# ACI Committee 376

## Concrete Structures for Refrigerated Liquefied Gas (RLG) Containment

### Agenda

## ACI 376 Gap Analysis Comments

Figure R7.1: Recommendations for increased reinforcing percentage parallel to bonded joints. *Note that a wall-to-base waterstop is required for both the primary and the secondary unlined concrete walls. The waterstop is optional for lined walls.*

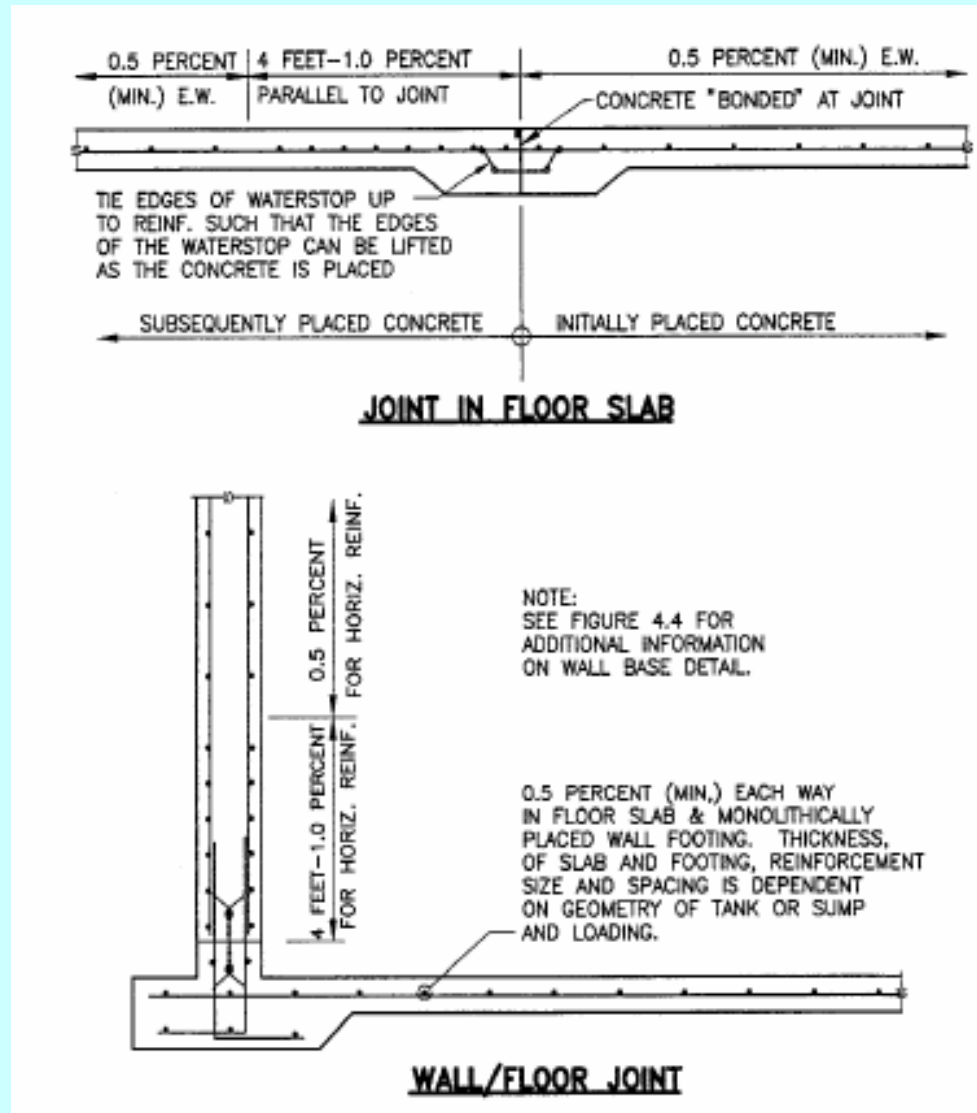
<p><b>Figure R7.1</b> The ballot proposes that the negative by Hoptay is found persuasive <b>in part</b>, and that the following note be added to the WALL/FLOOR JOINT part of Figure R7.1:</p> <p>WALL-TO-BASE WATERSTOP REQUIRED FOR UNLINED WALLS (PRIMARY AND SECONDARY); OPTIONAL FOR LINED WALLS.</p>	<p>Approved = 21 App w com = 0 Neg = 0 Abs = 2</p>

**Reason:** The proposed clarification is helpful, except that it should apply to both the primary and secondary containers (the latter in case of an accidental spill in the annular space).

**Appendix A – Tank Details**

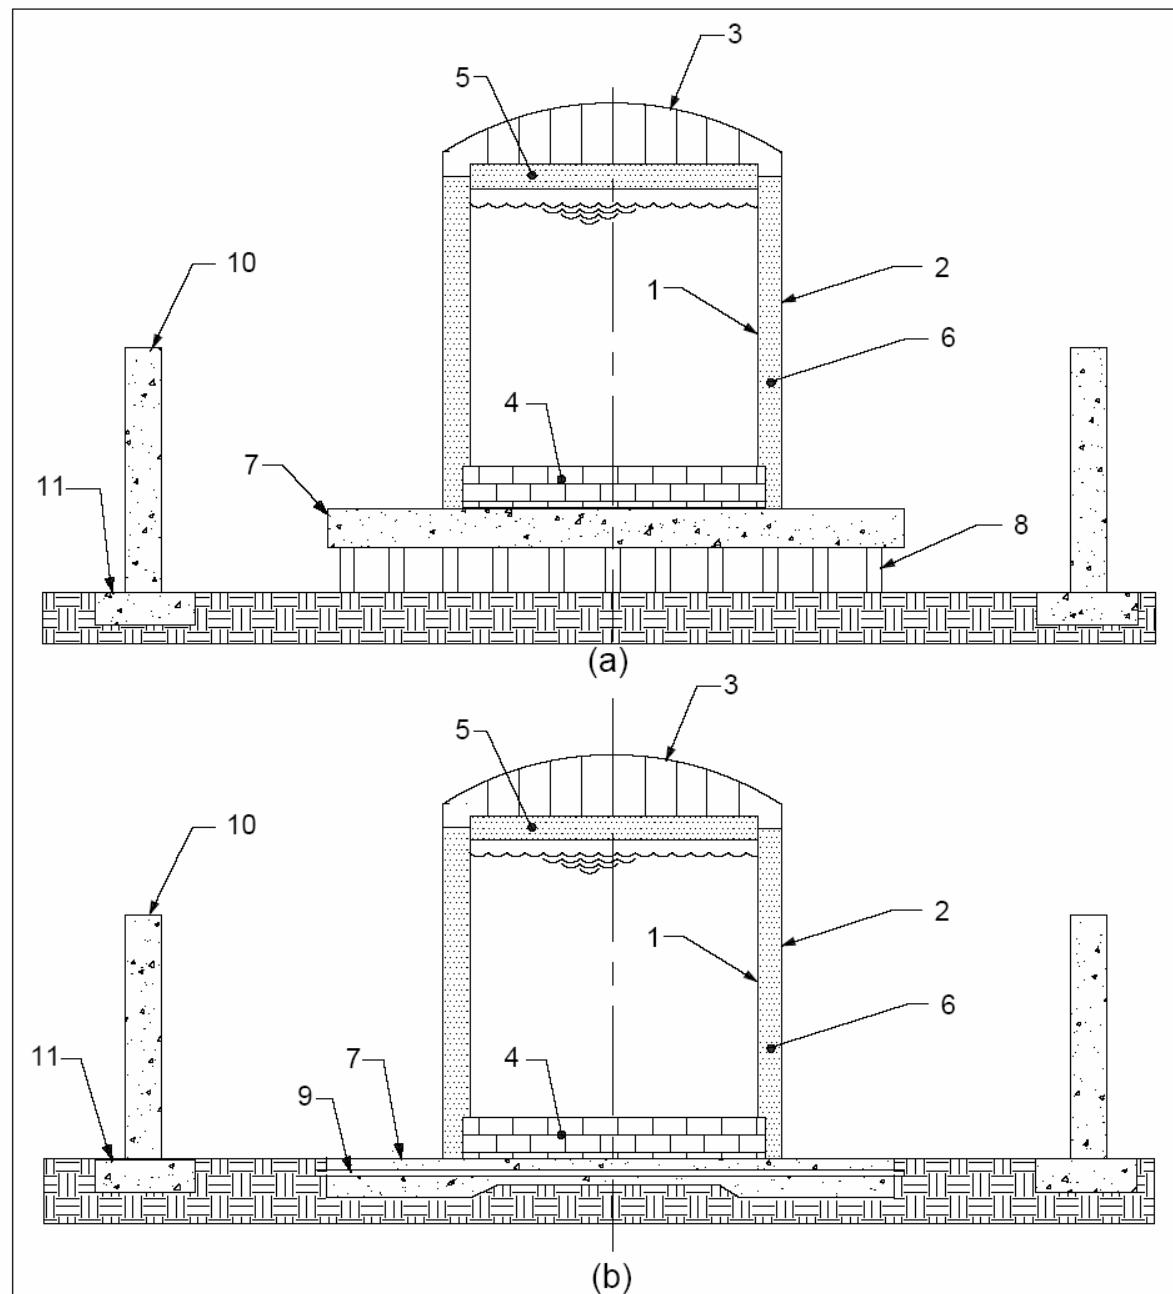
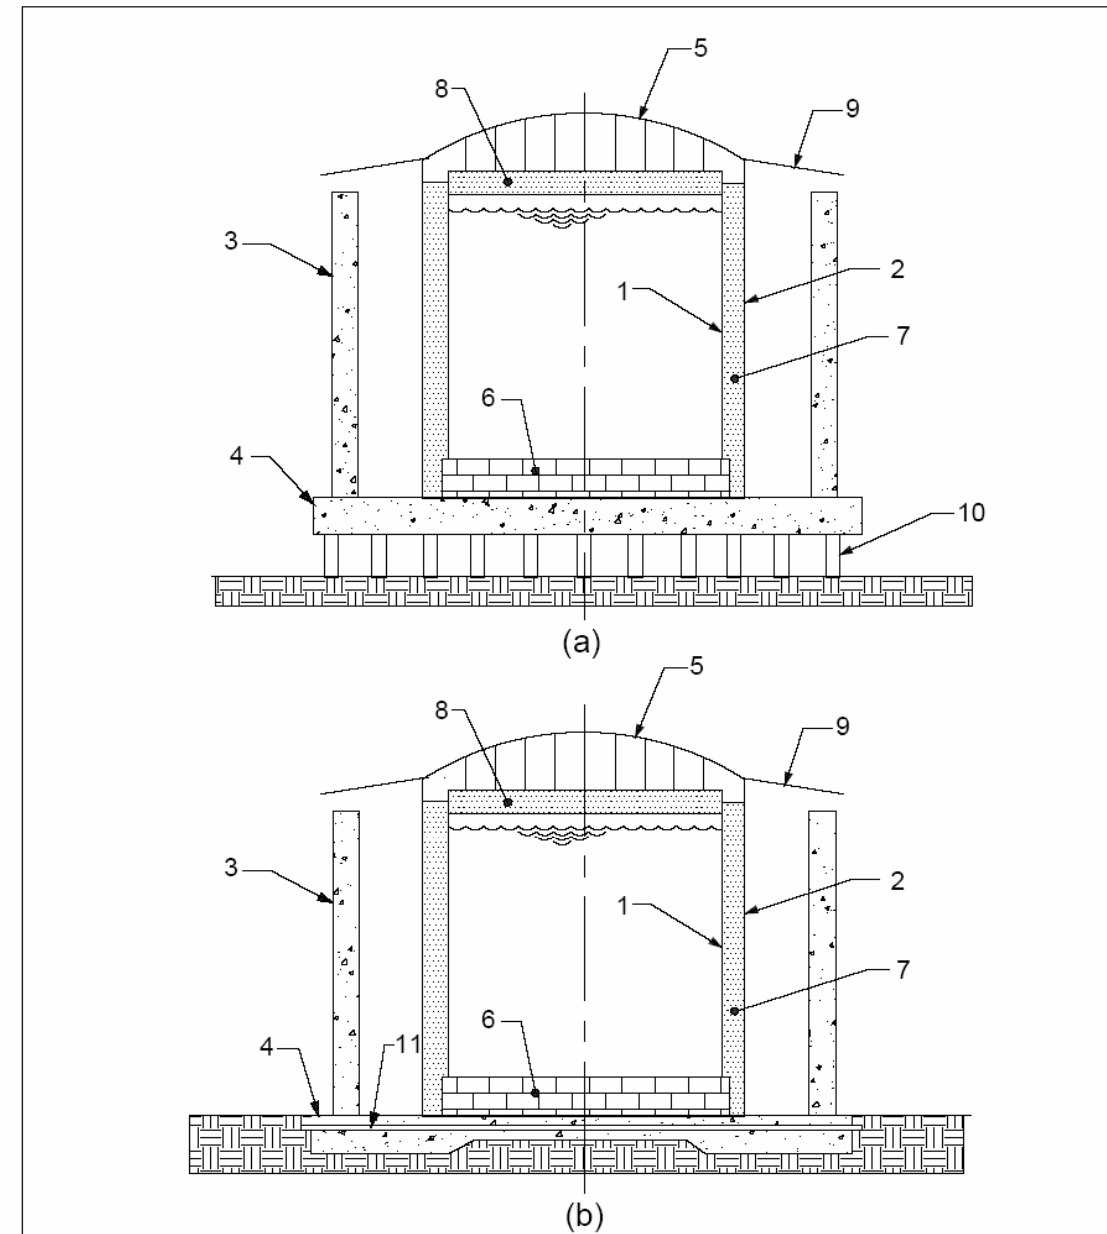
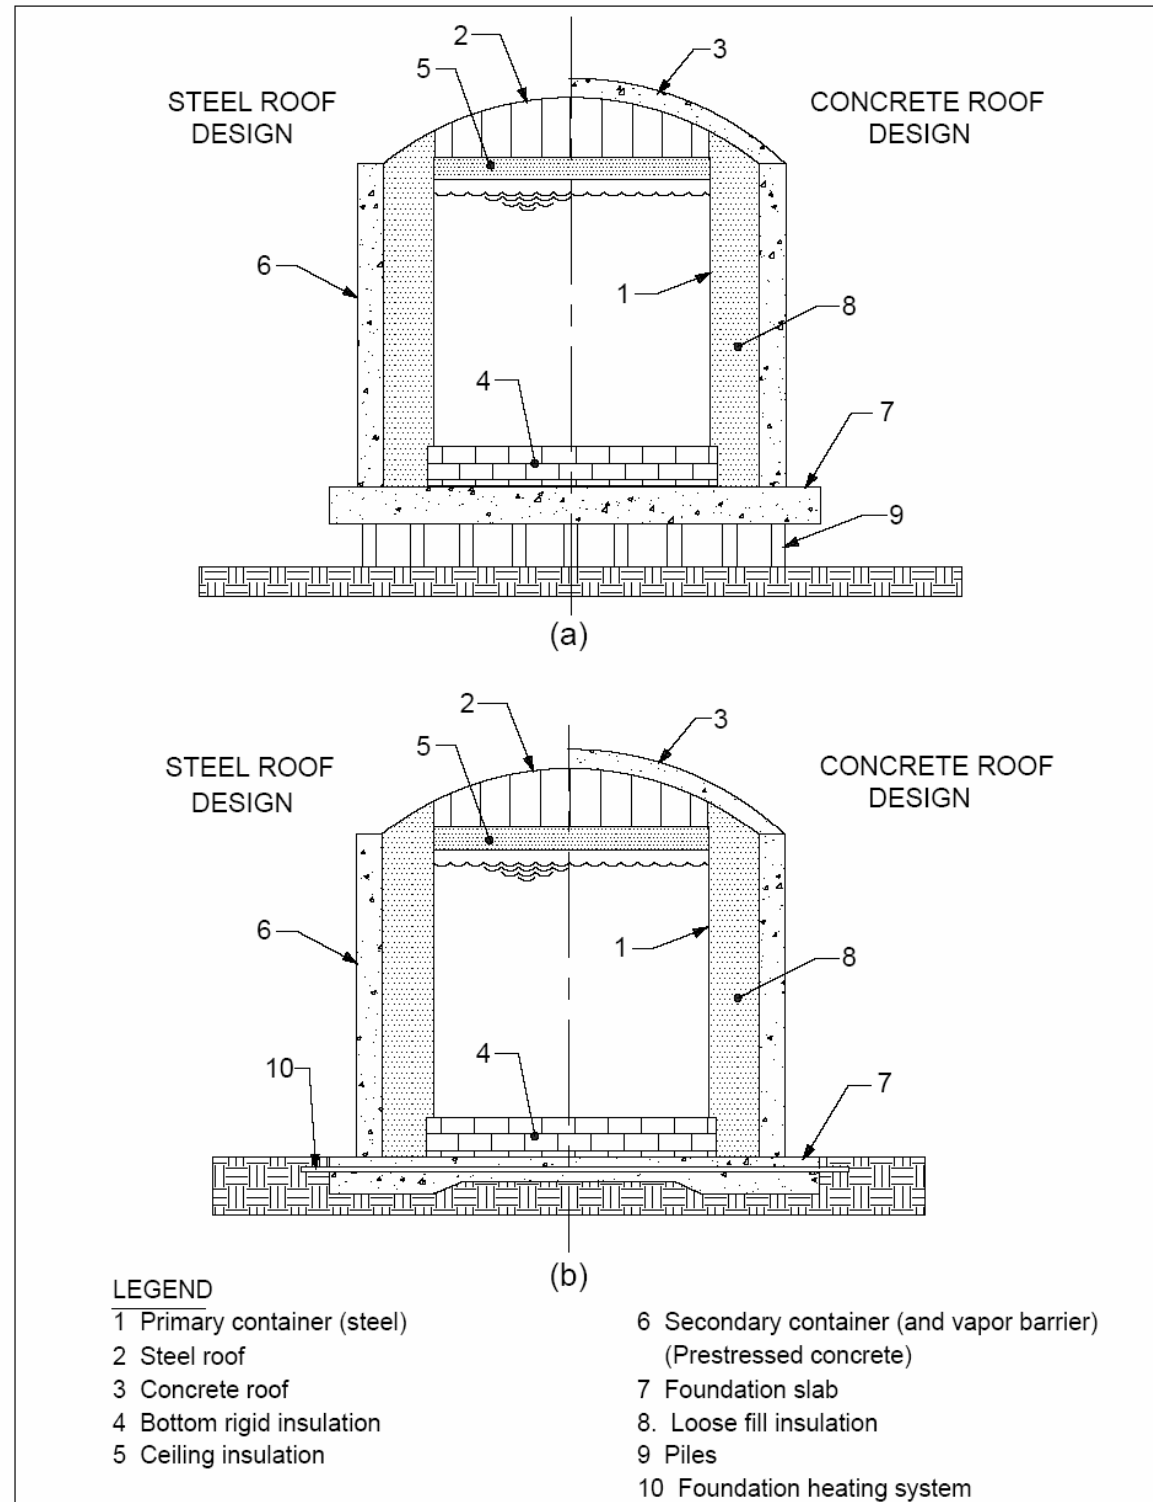
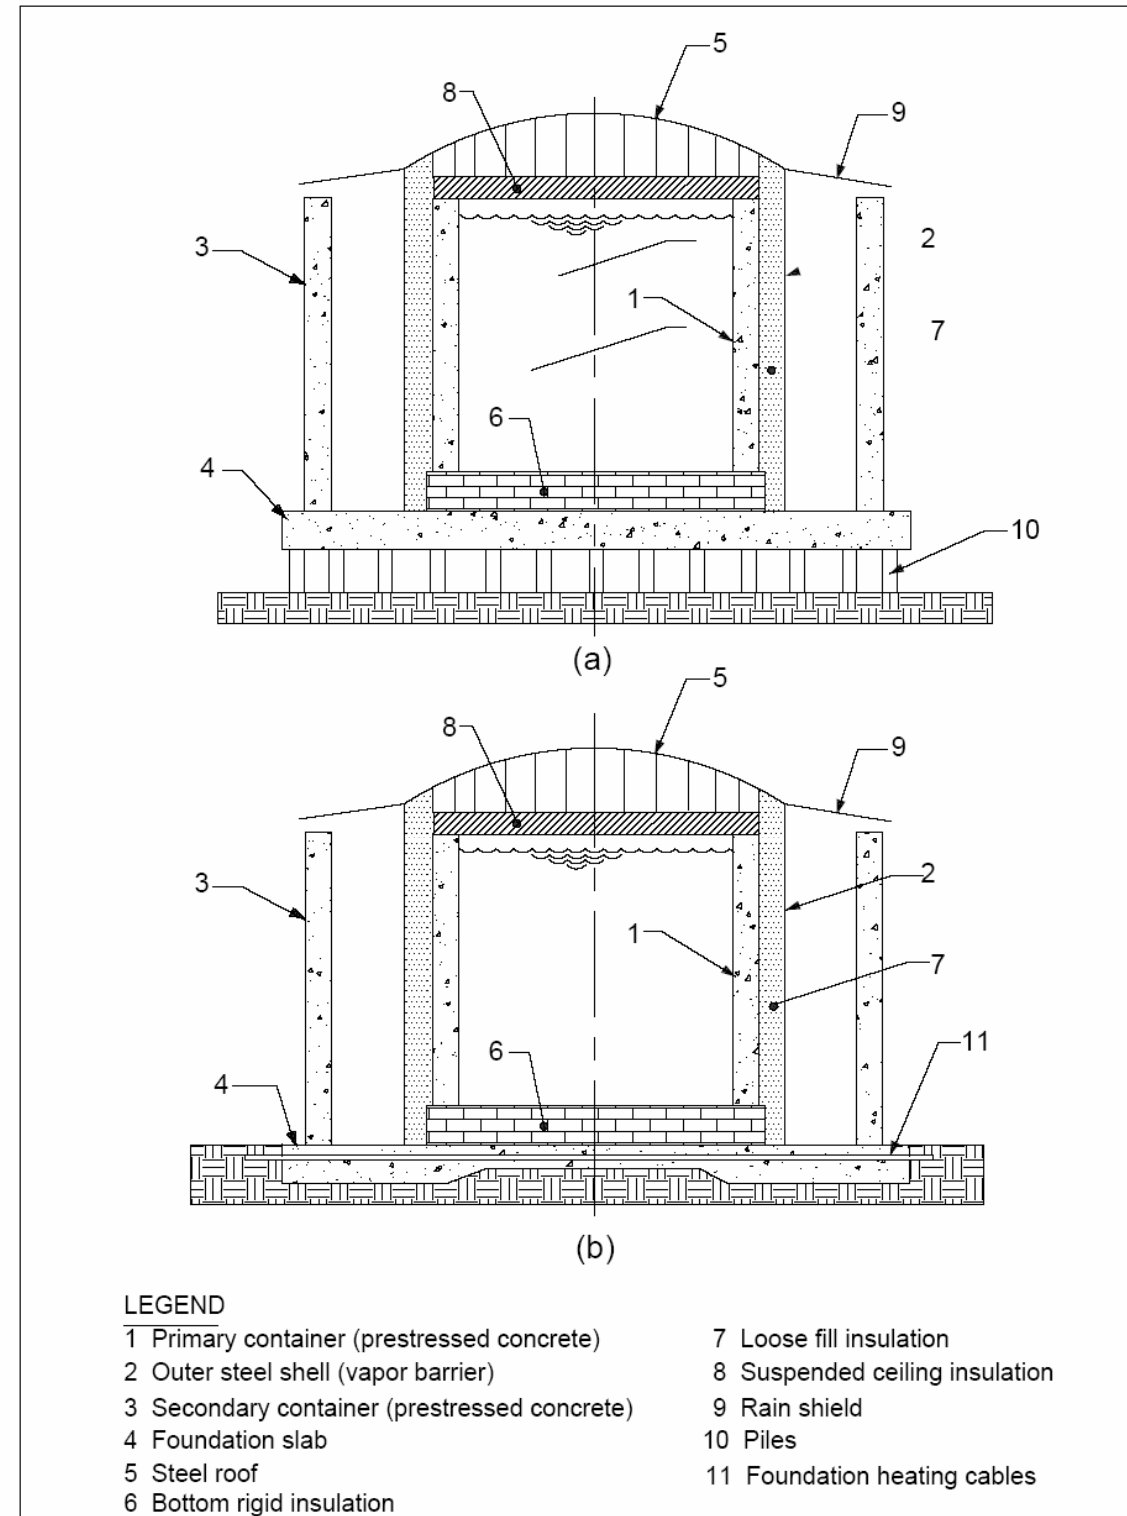
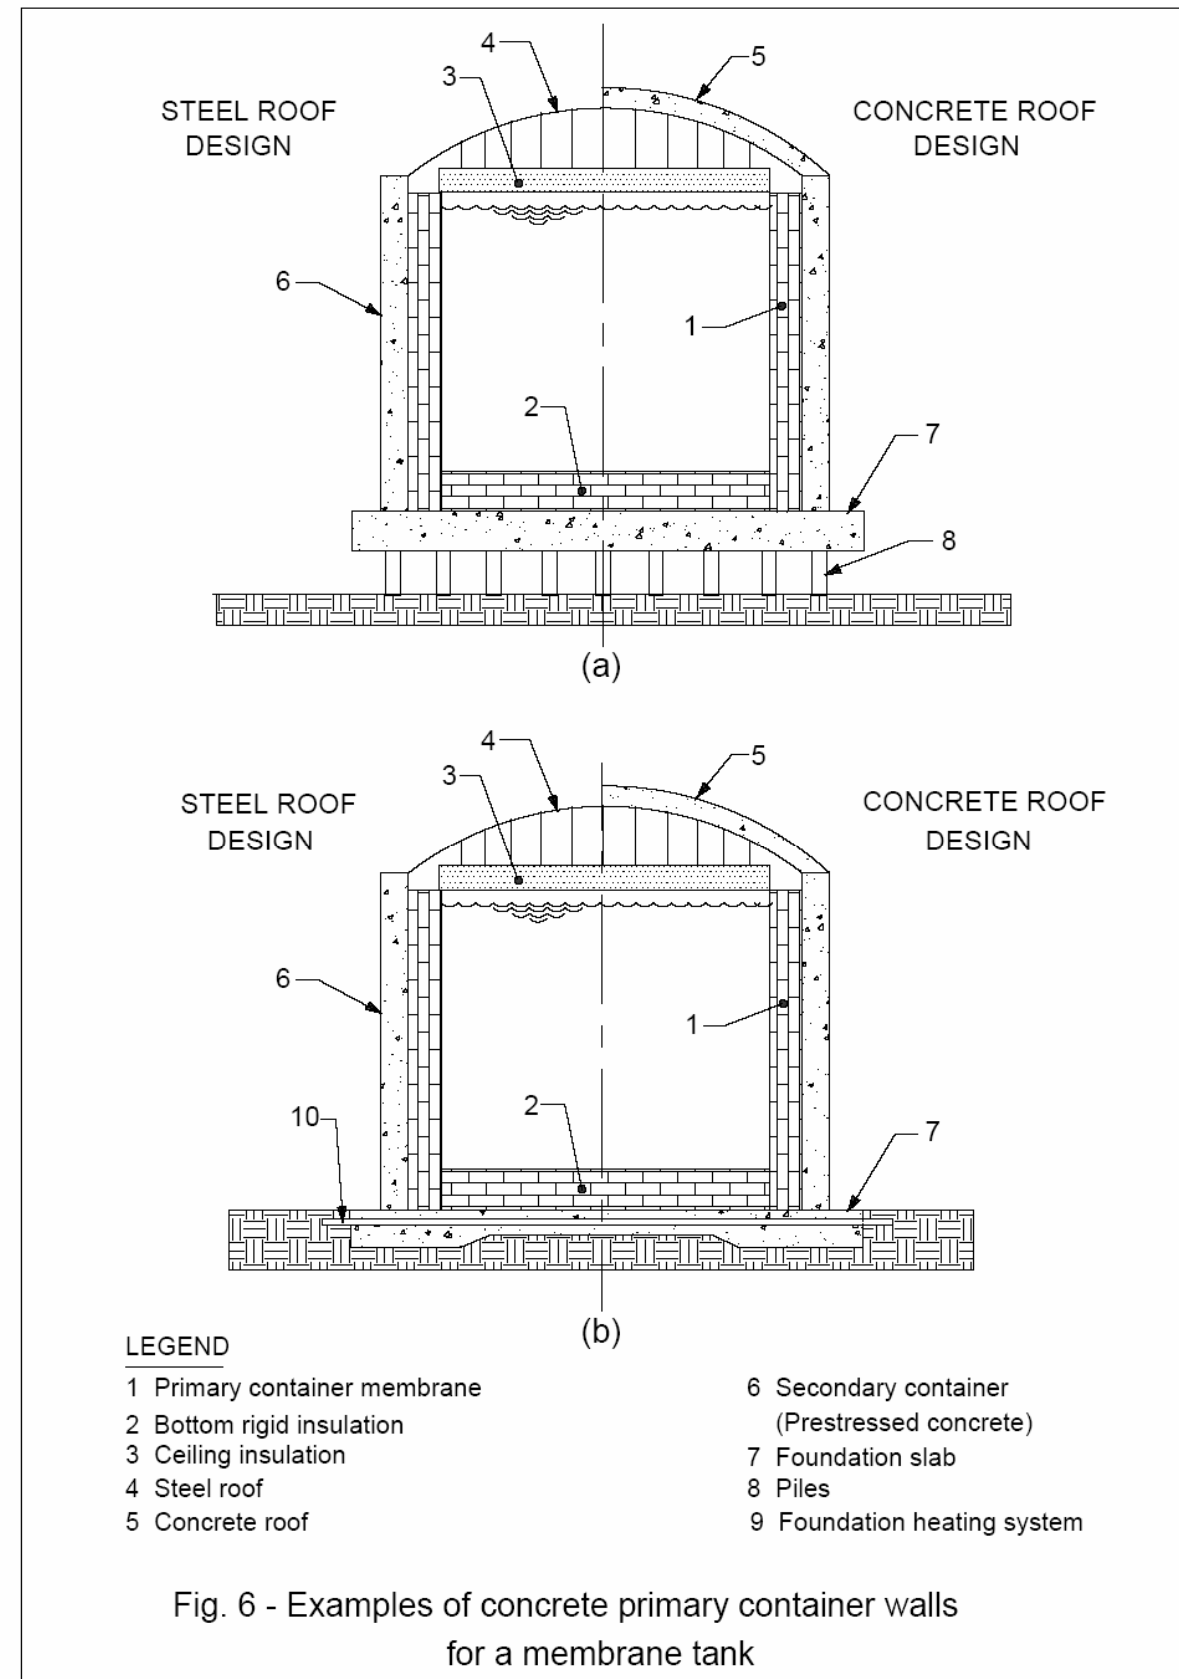
Text Balloted	Vote	Committee Members' COMMENTS	Author	RESPONSE	Notes
<p><b>APPENDIX A</b> <b>GENERAL COMMENT</b> The ballot proposes that the first negative by Hoptay is found persuasive, and that the six figures illustrating the different containment types be reintroduced in Appendix A (see the attached file).</p> <p><u>Reason:</u> There is a need for a series of figures illustrating the different containment types (single, double and full containment). Such figures were in fact included in the earlier drafts of this code and are cited in the last paragraph of Section R1.0; and they should be reintroduced in Appendix A.</p>	<p>Approved = 18 App w com = 1 Neg = 1 Abs = 3</p>	<p>Figure 6 can not be included in this standard since membrane tanks are not included in this standard. None of the chapters currently include any guidance from membrane tanks.</p>	Hoptay, Joseph	<p>Remove Fig 6 and update drawings</p>

<p>Agree with proposed change for Hoptay - Part 1, but think we should have these undated and redrawn in a format consistent with other graphics in Appendix A.</p>	Pawski, Rolf		
<p><b>APPENDIX A</b> <b>GENERAL COMMENT</b> The ballot proposes that the second negative by Hoptay is found not persuasive and that no changes be made in response to Part 2 of Hoptay's negative.</p> <p><u>Reason:</u> The details suggested by this comment (combining primary and secondary containers with cast-in-place and panel construction) do not lend themselves to unique, exclusive solutions. Instead, the designer should be allowed some latitude in developing these details to suit the needs of a particular project – as long as they satisfy the prescribed performance criteria.</p>	<p>Approved = 19 App w com = 1 Neg = 0 Abs = 3</p>	<p>While it is recognized that the designer should have latitude to develop details that meet a particular project need, the minimum performance criteria, design and analysis and details all need to recognize all possible design concepts that are currently envisioned and provide guidance for those concepts</p>	Hoptay
